BID
ADDENDUM #03

FOR THE
RENOVATION TO MAIN
TELECOMMUNICATIONS
ROOM

AT
WEST VALLEY COLLEGE

Bid #2-1415

Sketch	ASK-01 02/A3.10	Revision	Addendum C
Job. No.	13122.10	Description	Addition of uniform rigid insulation board over new framing
Reference	A3.10		
Date	2/4/15		
Scale	NTS

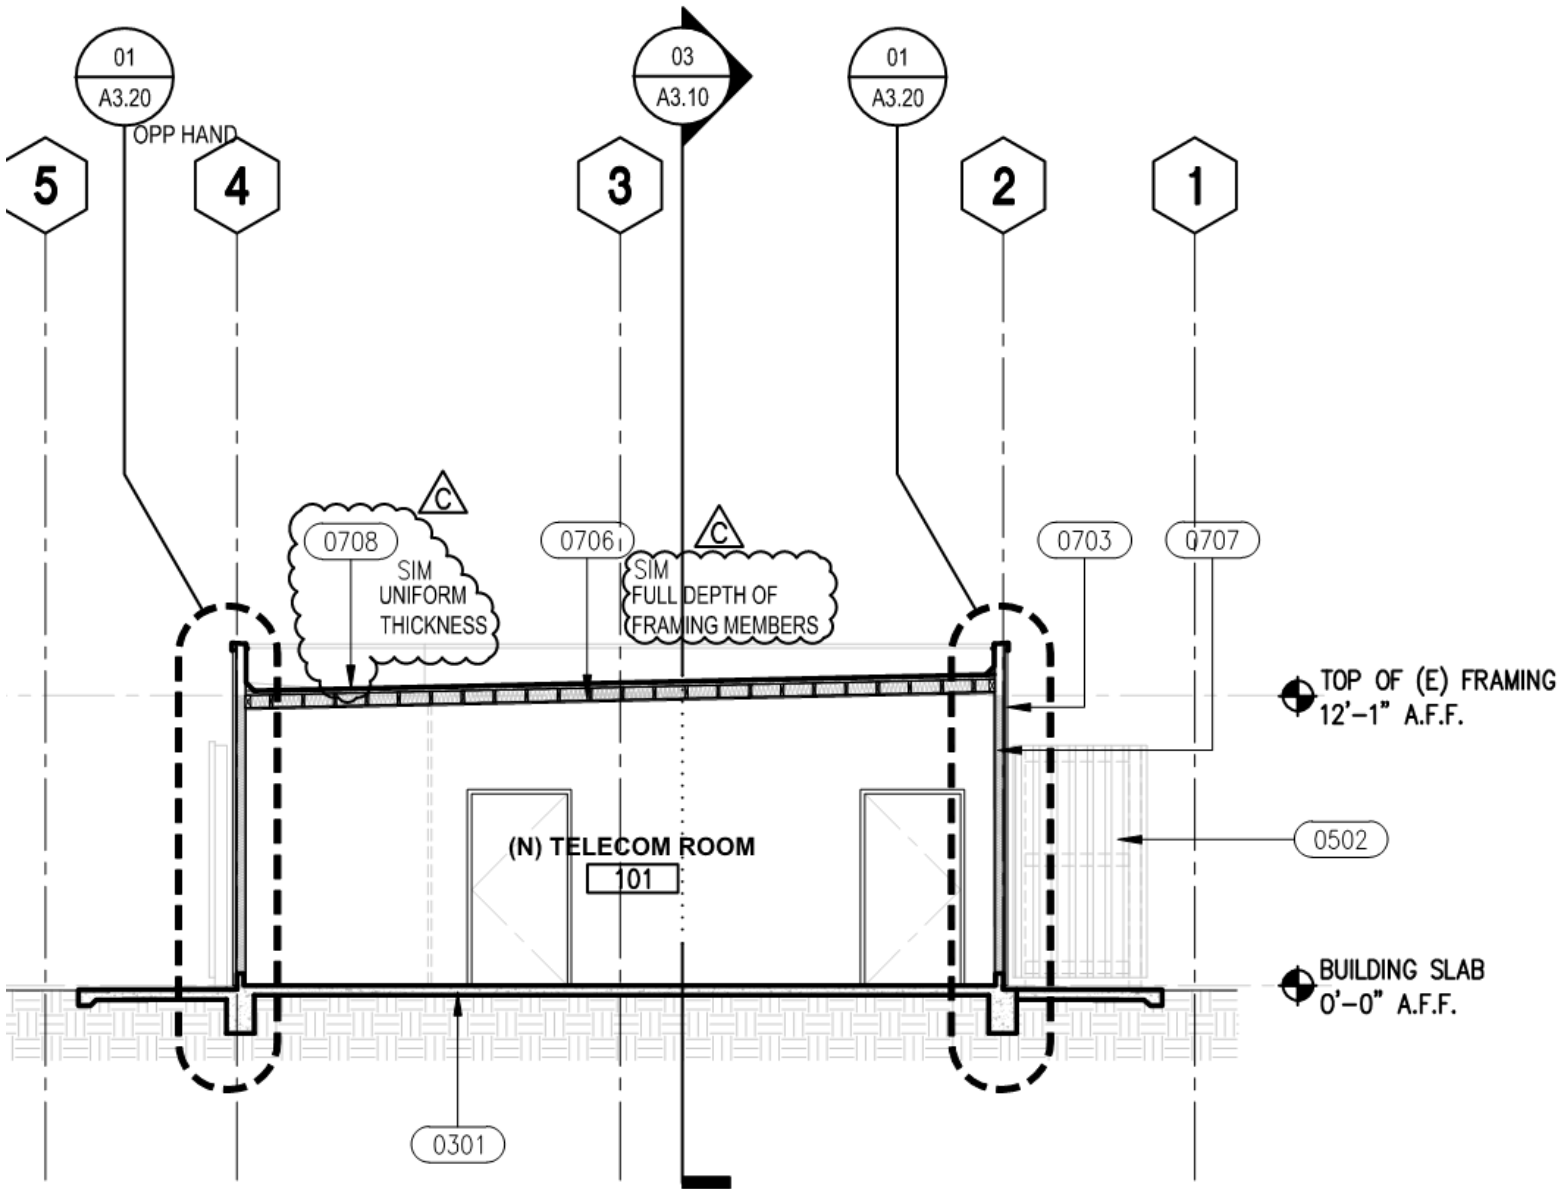
- ITEM NO. 1** Sketch revision ASK-01 of 02 / A3.10. Revised to indicate uniform layer of rigid insulation board over new 2x construction. Revision to keynote to indicate batt insulation to fill full depth of framing.

Sketch	ASK-02 03/A3.10
Job. No.	13122.10
Reference	A3.10
Date	2/4/15
Scale	NTS

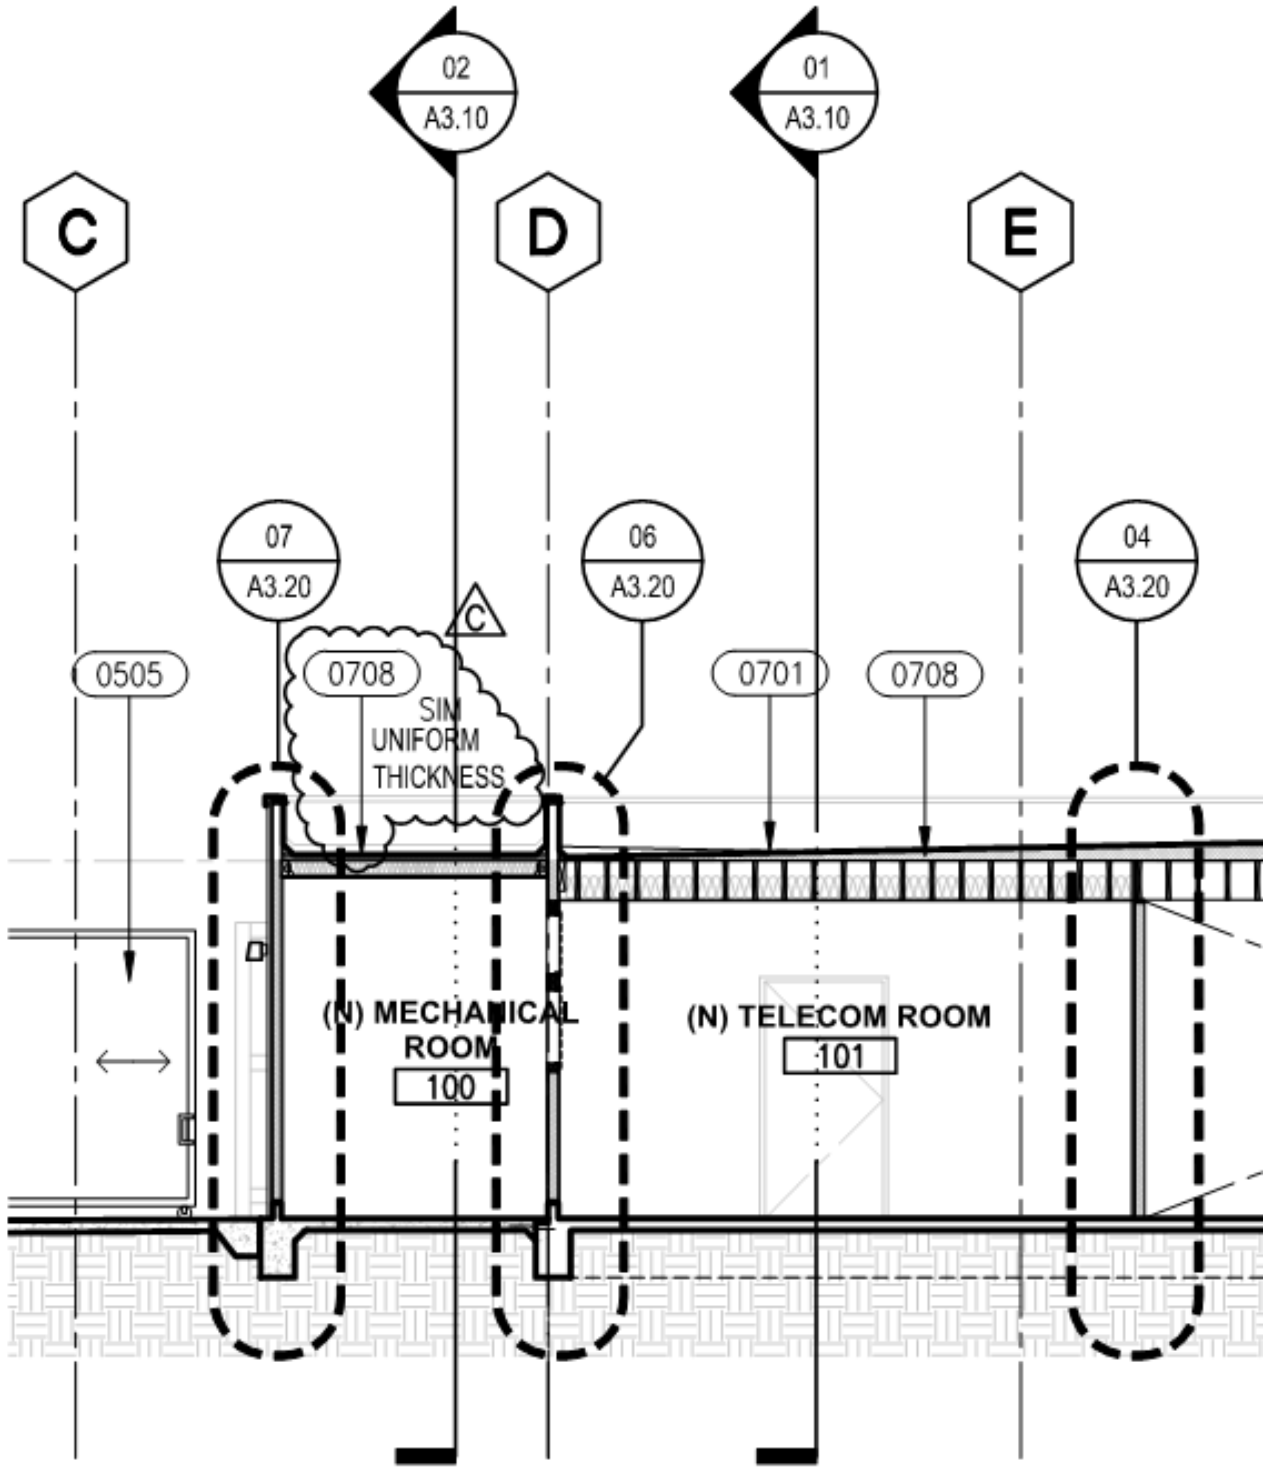
- ITEM NO. 2** Sketch revision ASK-02 of 03 / A3.10. Revised to indicate uniform layer of rigid insulation board over new 2x construction. Revision to keynote to indicate batt insulation to fill full depth of framing.

Sketch MSK-01
PARTIAL MECHANICAL PLAN

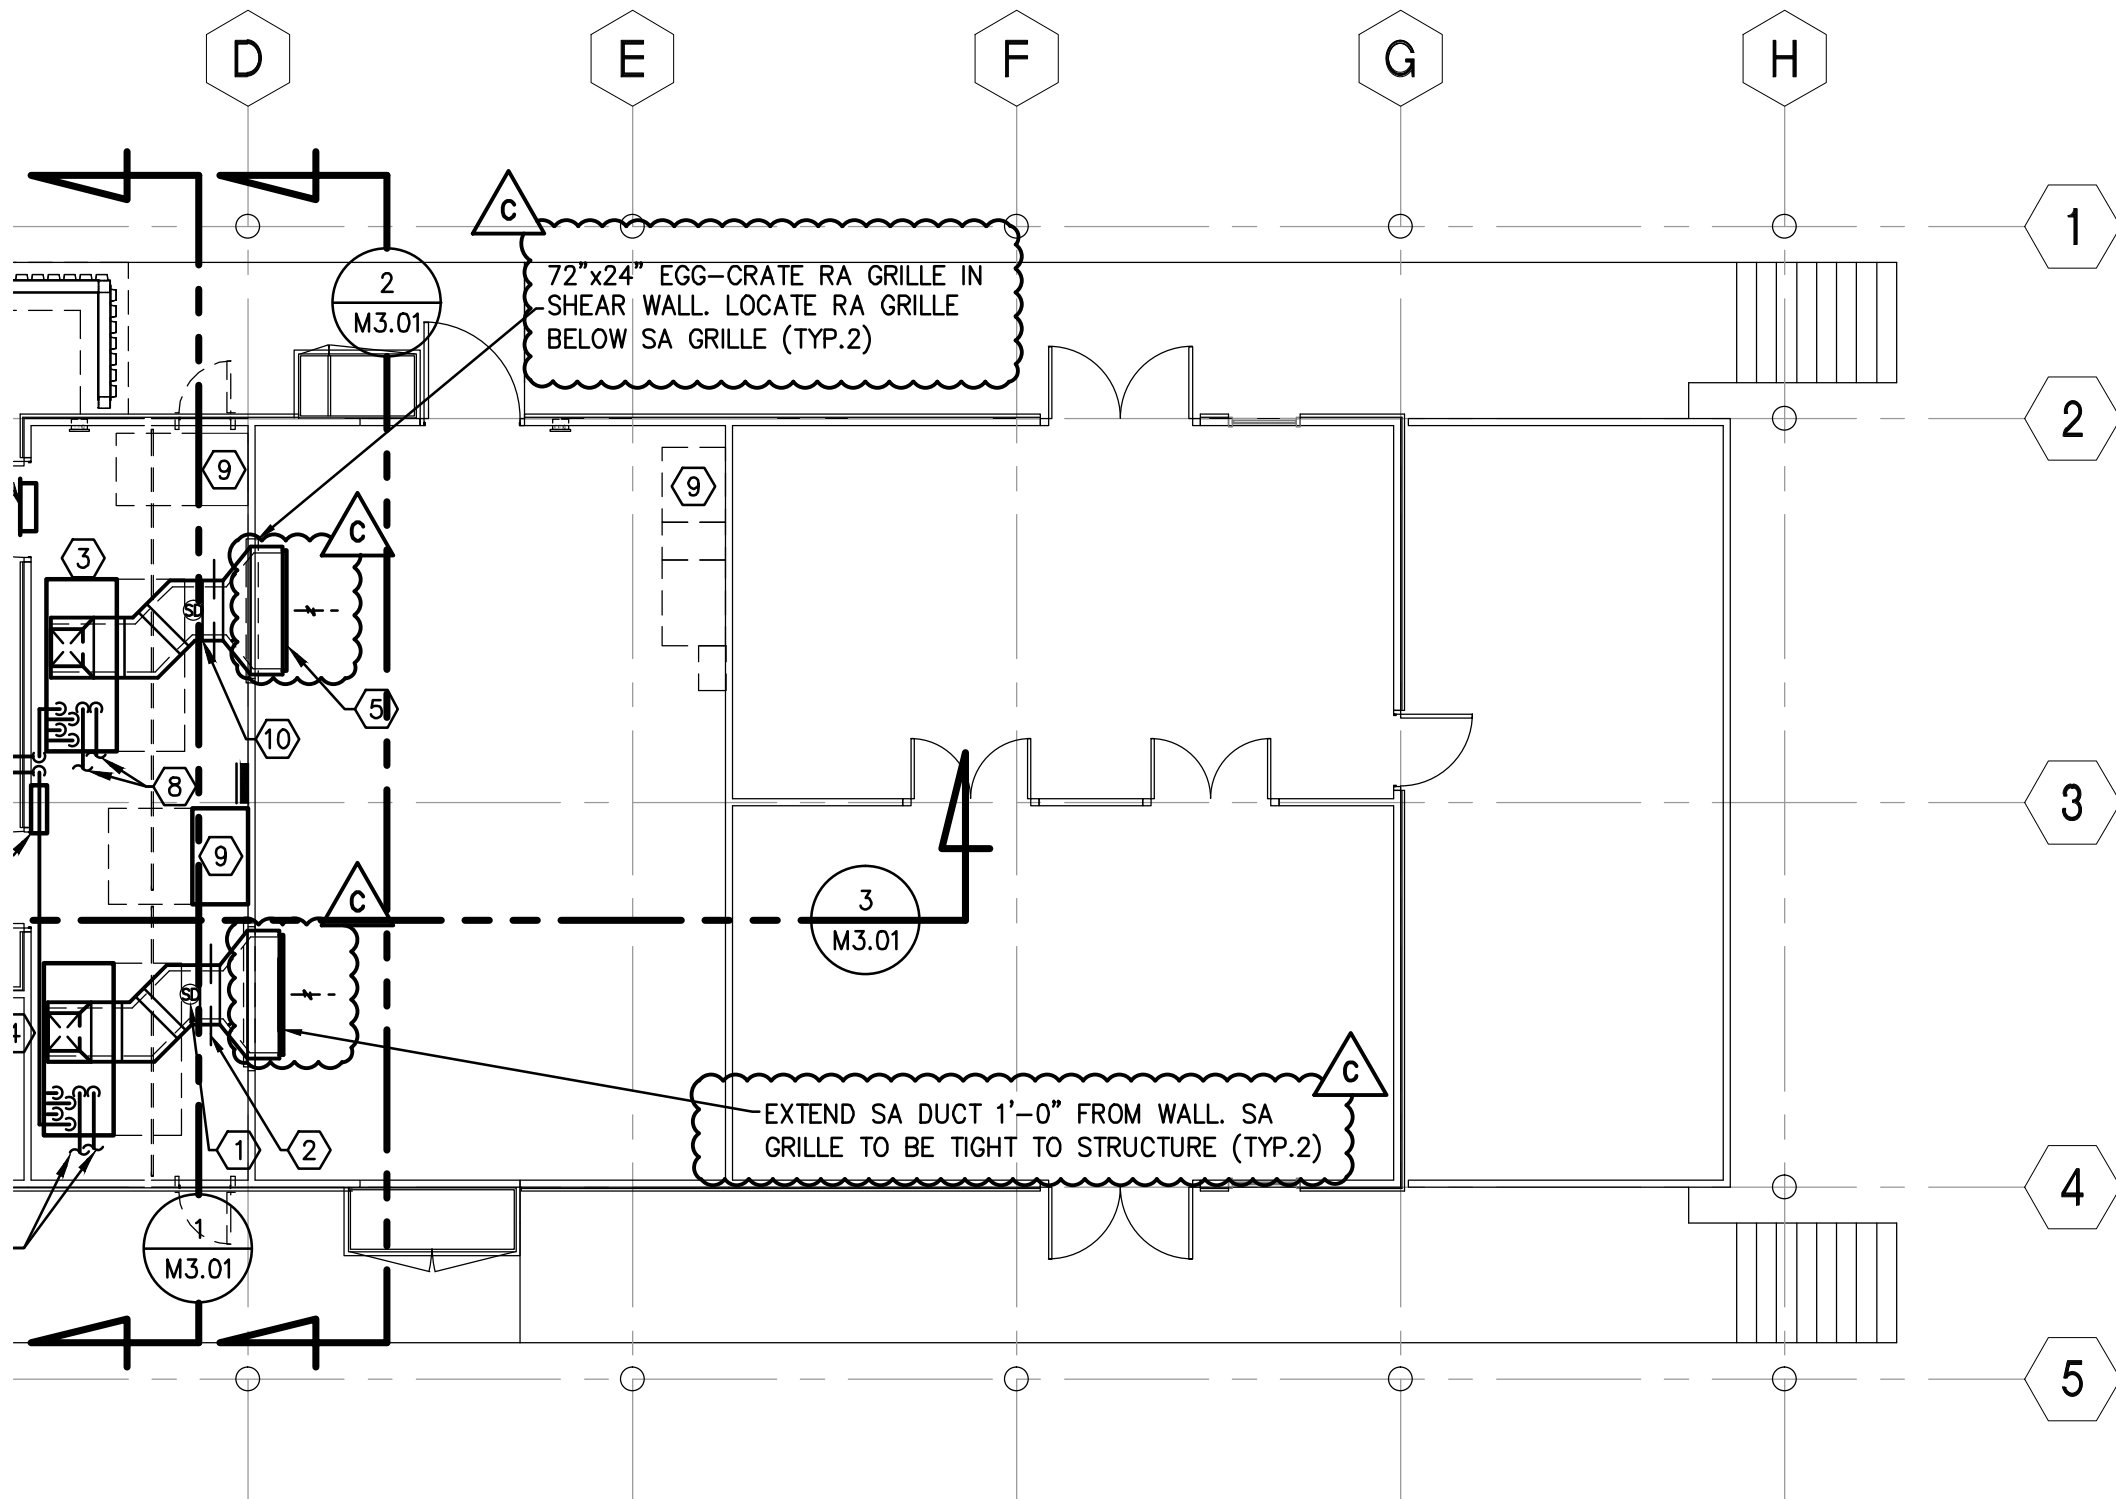
- ITEM NO. 3** Sketch revision MSK-01 of 01/M2.01
1. Return air grille size revised from 72"x30" to 72"x24".
 2. Keynote 5 denoting supply air grille size revised from 60"x24" to 60"x18".

3. Supply air grille extended 1'-0" from shear wall to prevent SA short cycling.
 4. Note changed to reflect new RA grille type as Egg-Crate.
- ITEM NO. 4** Sketch revision MSK-02 of 02/M3.01

MECHANICAL SECTION 2

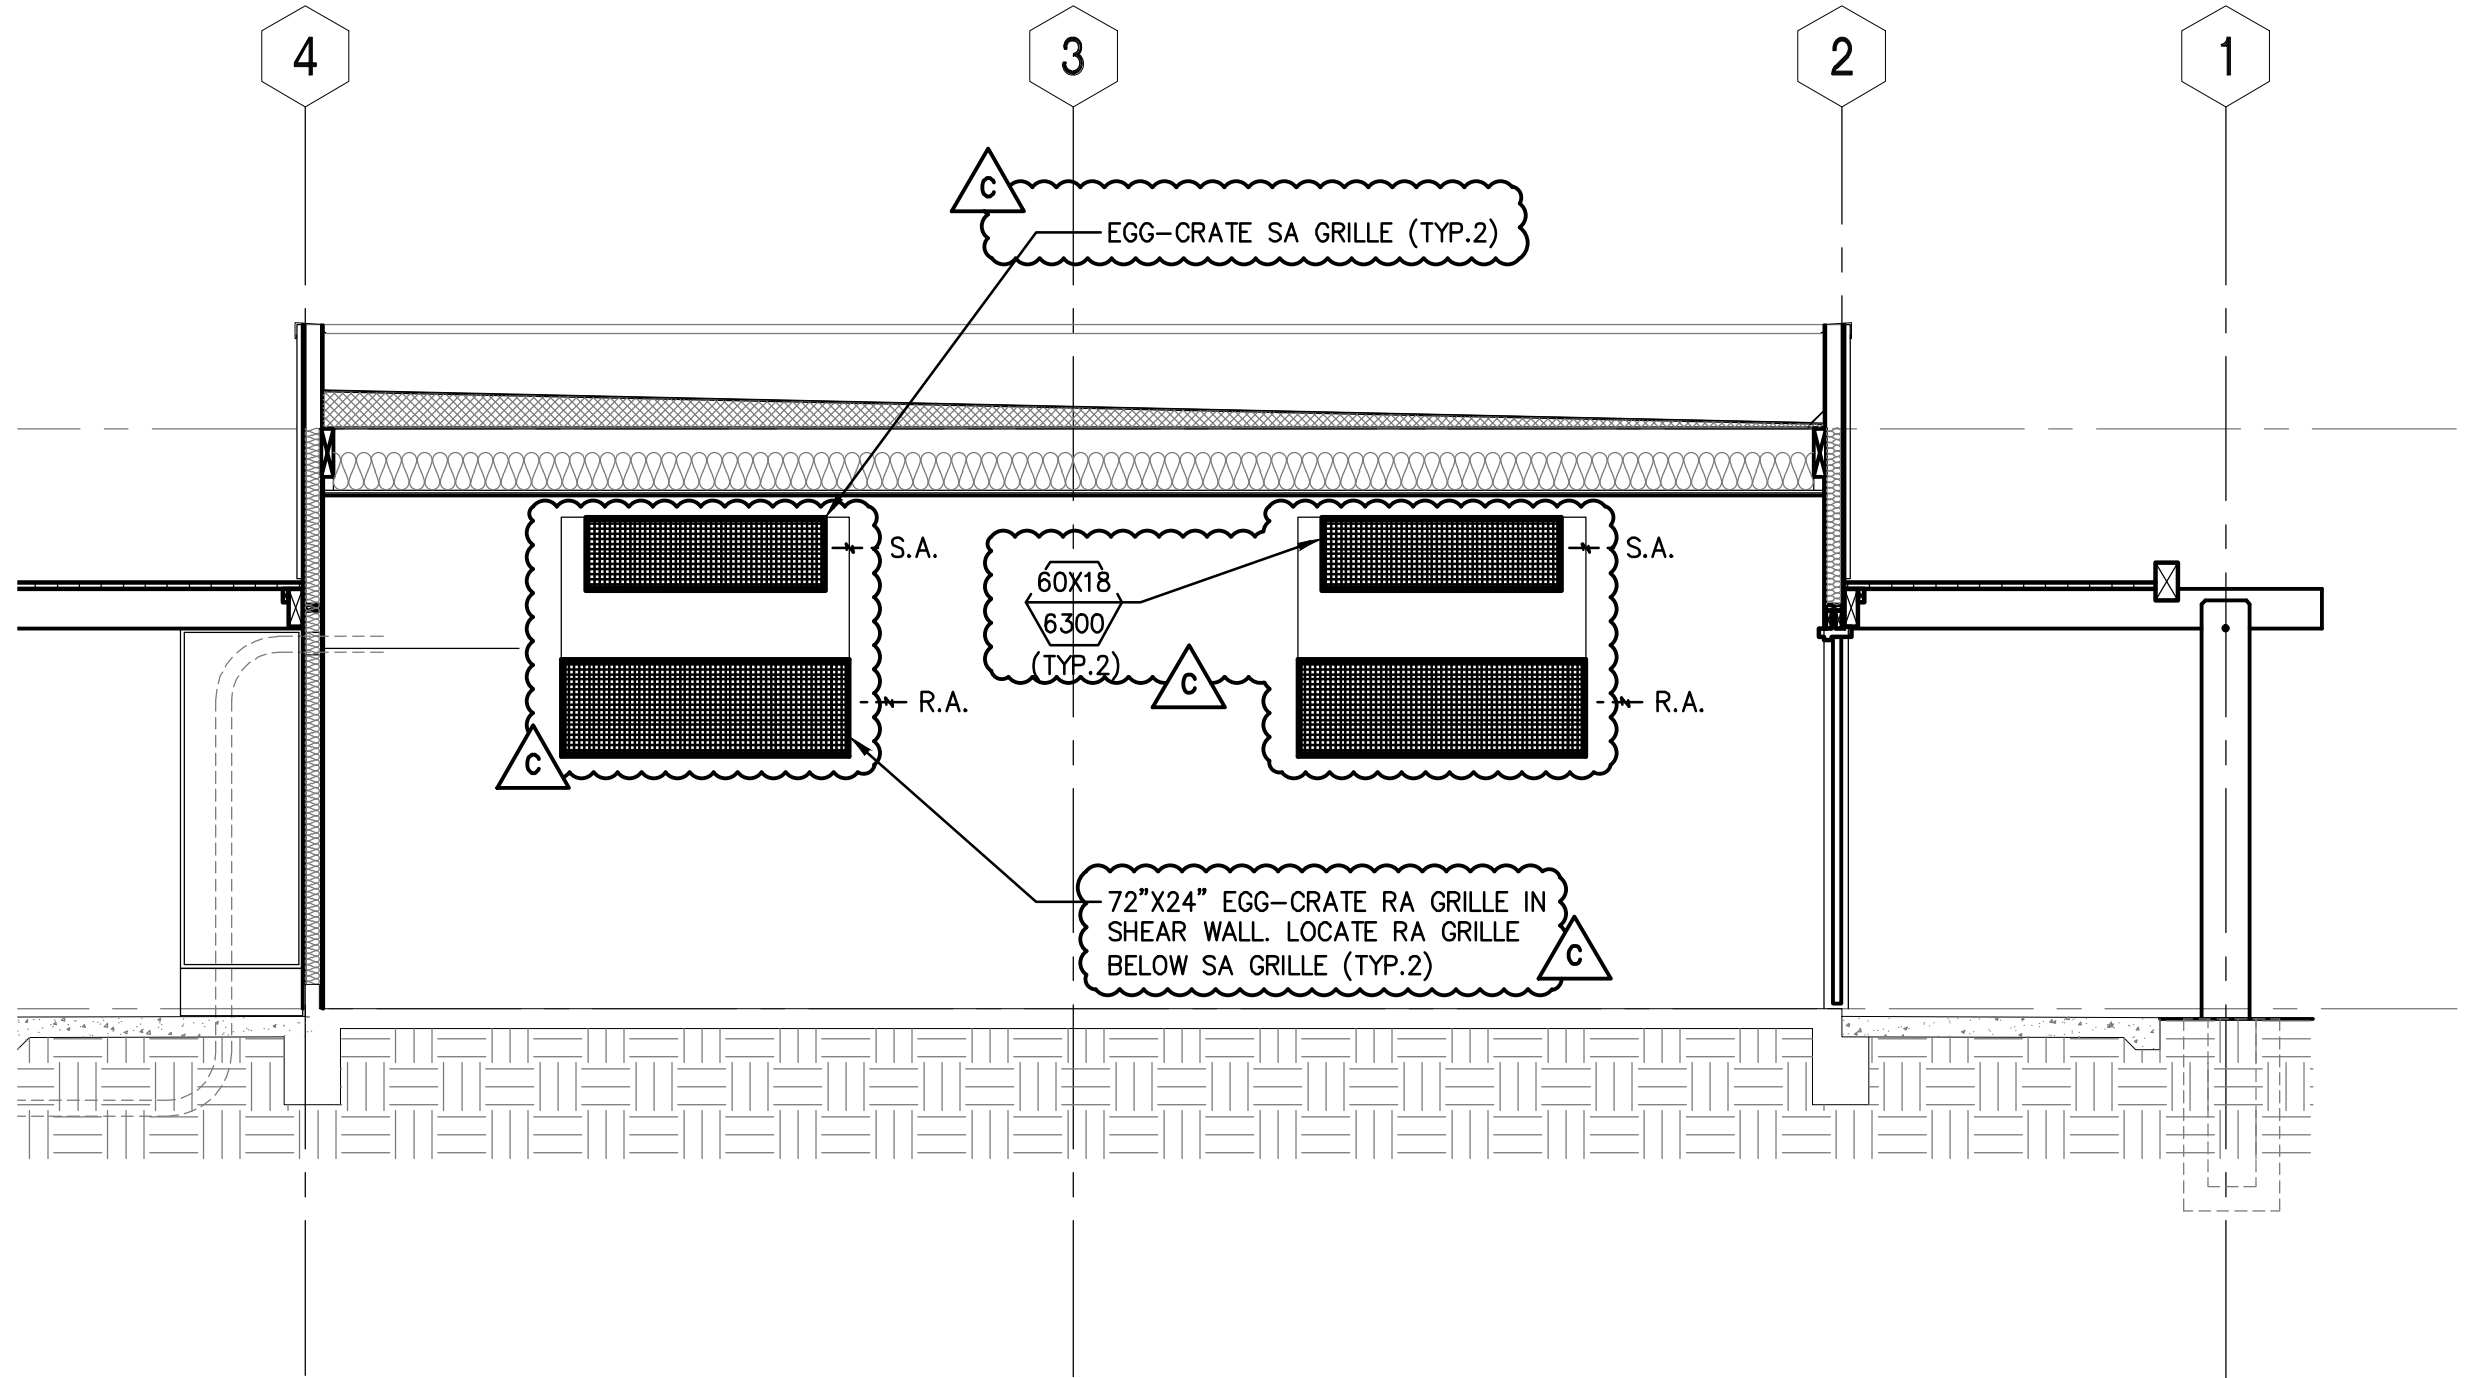
1. Note added calling out SA grilles as type Egg-Crate.
 2. Hex callout changed to reflect new SA grille size.
 3. New supply and return grilles pushed to upper and lower edges of original shear wall opening.
